SITE PLAN LAYOUT
PARCEL 'B'
ADDRESS: 8915 BLUE ASH ROAD
GRASSCOR LAWN AND LANDSCAPING, LLC.
SECTION 14, TOWN 4, ENTIRE RANGE 1
SYCAMORE TOWNSHIP
HAMILTON COUNTY, OHIO

Drawn By: J.KAFFENBERGER
SYCAMORE TOWNSHIP PLANNING & ZONING
SHEET 3 OF 5
C-1.0
Job No: 7806-12

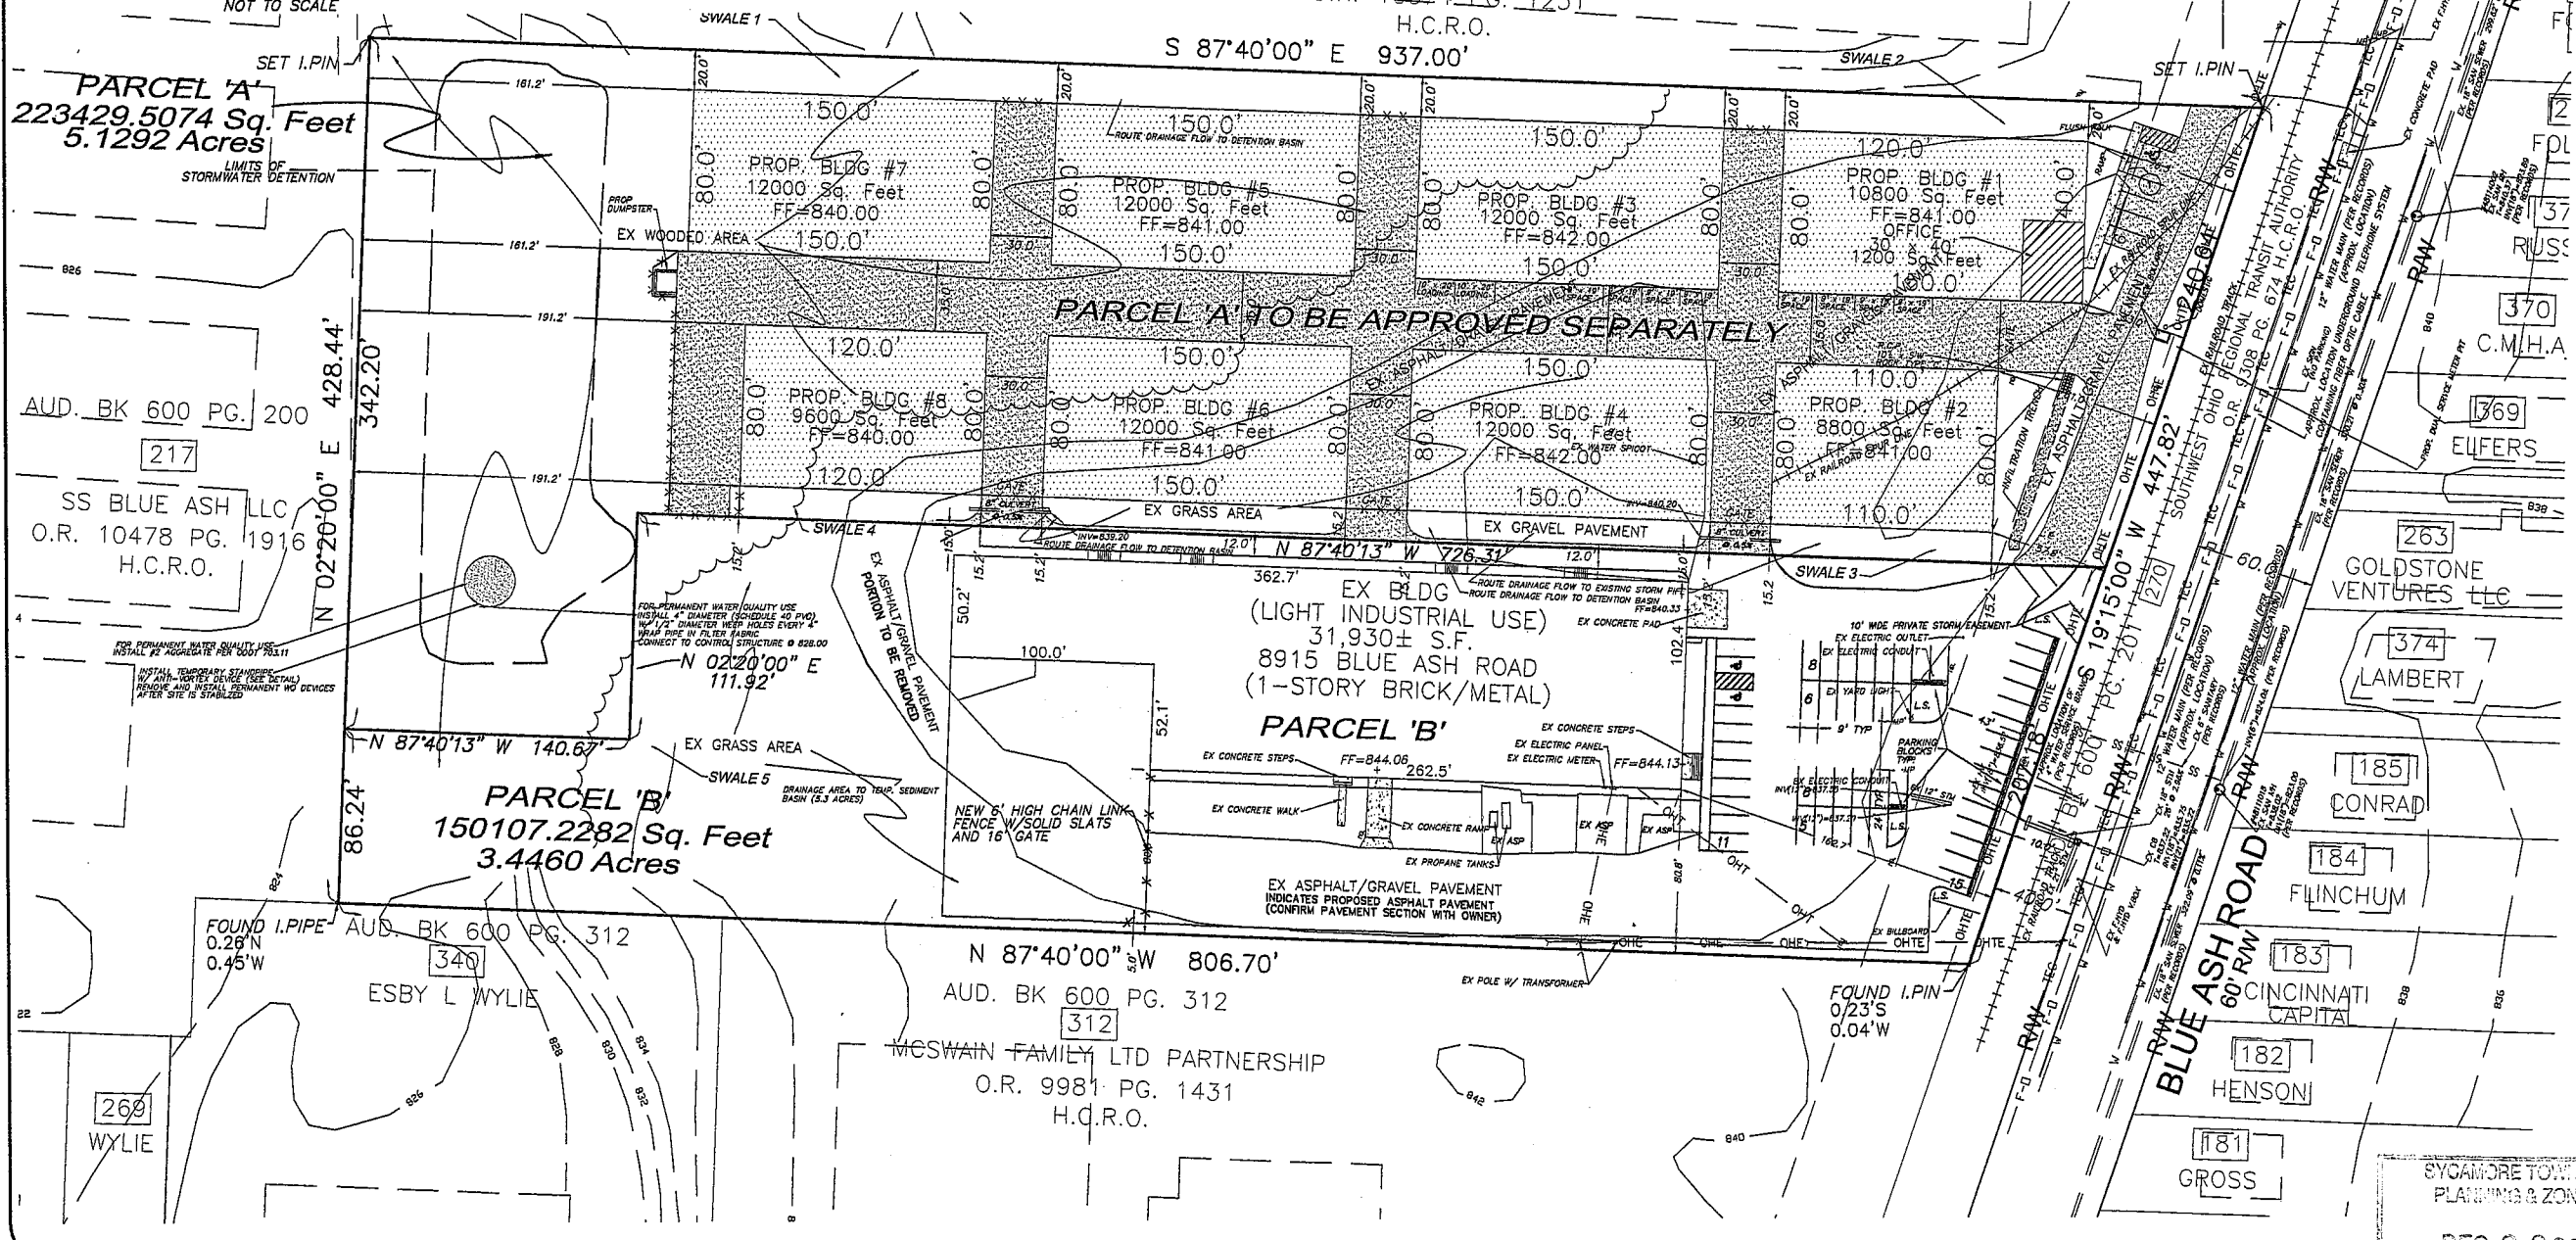
- All landscaping and the drainage basin must be completed as part of phase one of construction.
- Until the time when construction begins on phases two and three, that area must be seeded and maintained.

- If phases two and three are not completed within five years of the issuance of a temporary certificate of occupancy for phase one, the applicant must come back before the Zoning Commission for approval.

- The board will grant a variance to allow the dumpster to be screened by an alternate suitable material as opposed to brick or stone required by code.

- The interior landscape requirement is to be waived.
- The board will grant a variance to allow for the location of the office parking to be constructed as proposed on the northern property.

- All site work around the Grasscor building, including paving and striping of the parking stalls must be completed before certificate of occupancy is issued.

- The board will waive the requirement for a landscape buffer on the north and interior boundaries except for landscaping detailed on drawing L1 with the number and type of plantings per the Zoning Resolution.

- The Western and southern buffers must be maintained as shown on the illustrated site plan.
